FILE STP-F001-00(098) Oconee County
P. I. No. 0001098

SUBJECT PROJECT CONCEPT REPORT APPROVAL

PROJECT CONCEPT REPORT

Project Number: STP-F001-00 (098)
County: Oconee
P. I. Number: 0001098

**PROPOSED INTERSECTION CONFIGURATION OF
EPPS BRIDGE ROAD AT JENNINGS MILL PKWY**

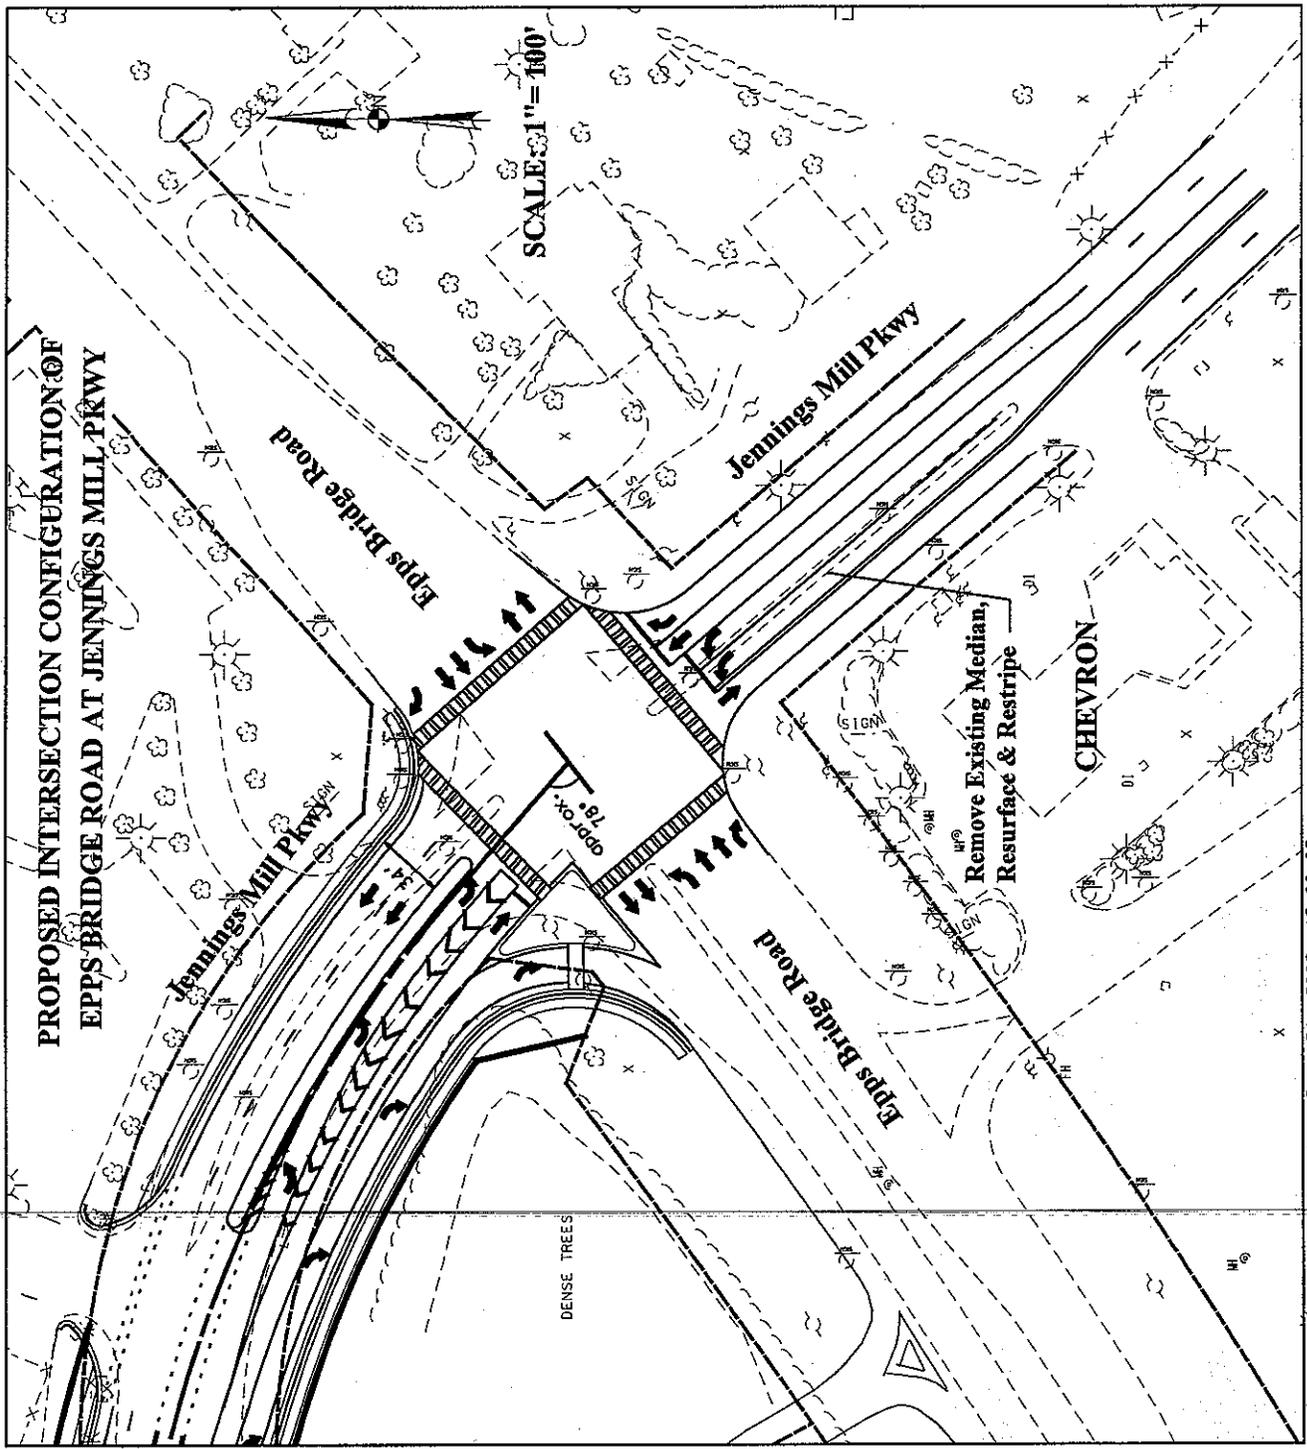
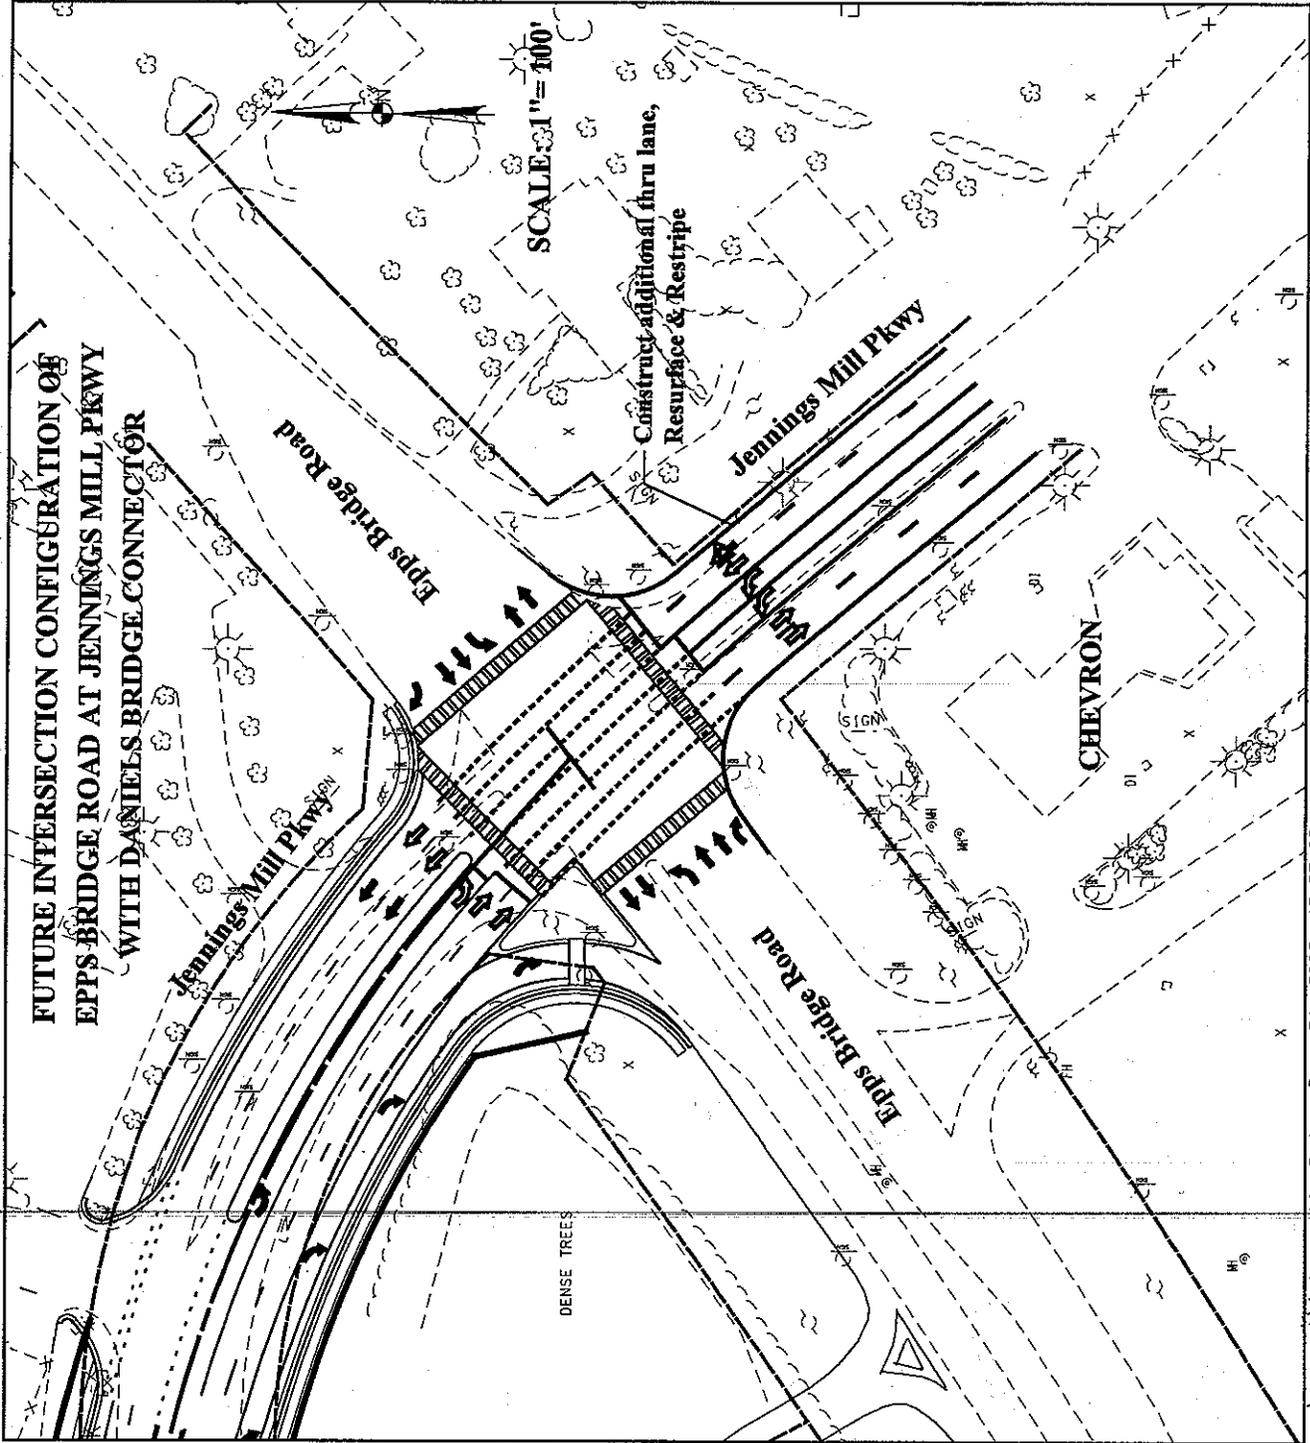
Mr. Stanley Hill then opened discussion and comments about the design exception and the intersection of Jennings Mill Parkway at Epps Bridge Road. Mr. Hill stated that the intersection should be realigned, perhaps with a slight skew. Mr. Mike Leonas noted that grade change problems at Lowe's would require significant slope easements onto Lowe's. Ms. Poshedly stated that GDOT would be revising the intersection in the future as part of the S.R. 316/U.S. 78 Interchange reconstruction and that this intersection could be modified later as part of that project. Mr. Hill noted that instead GDOT could match the intersection grades that are used in this project.
